MATANUSKA-SUSITNA BOROUGH

PLATTING BOARD AGENDA ASSEMBLY CHAMBERS 350 E DAHLIA AVENUE PALMER

December 4, 2025

- 4. UNFINISHED BUSINESS
- 5. RECONSIDERATIONS/APPEALS
- 6. PUBLIC HEARINGS
 - A. PROSPERITY SOUTH: The request is to create eight lots from Tax Parcel C8 (Parcel #1, MSB Waiver 76-4, recorded 79-245w), to be known as Prosperity South, containing 10.00 acres +/- (Tax ID# 18N01W35C008). Parcel is located east and south of N. Wasilla-Fishhook Road. Access is from N. Jaybird Place, lying within the SW 1/4 Section 35, Township 18 North, Range 01 West, Seward Meridian, Alaska. In the Tanaina Community Council and in Assembly District #6. (Petitioner/Owner: Precision Homes LLC, Staff: Chris Curlin, Case # 2025-142)

Subject: RFC Erinwood 2025 (MG)

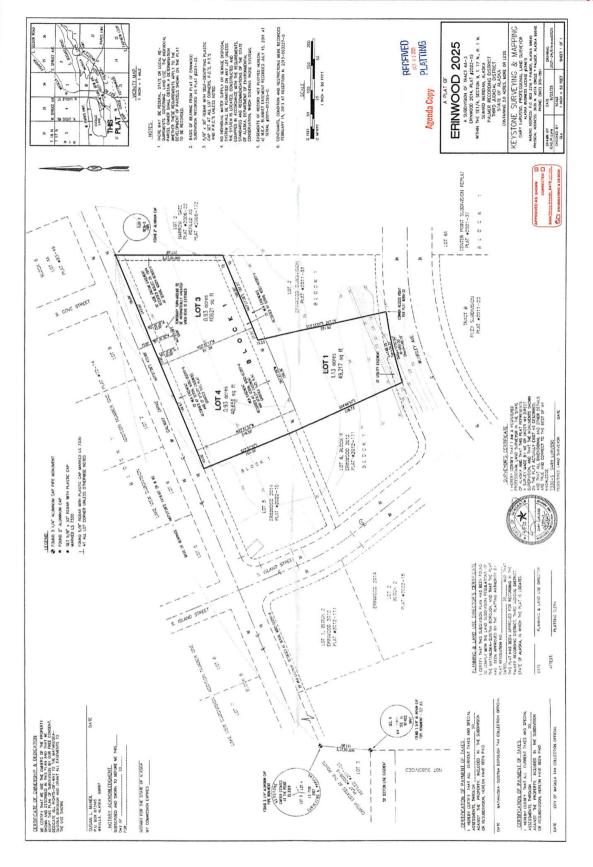
Could we add 'And 15' UE granted this plat' where circled on the attached to avoid any confusion? No other comments.

- 3. Pay postage and advertising fees.
- 4. Add "and 15' Utility Easement granted this plat." To the MEA easement on the southern boundary of proposed Lot 3.
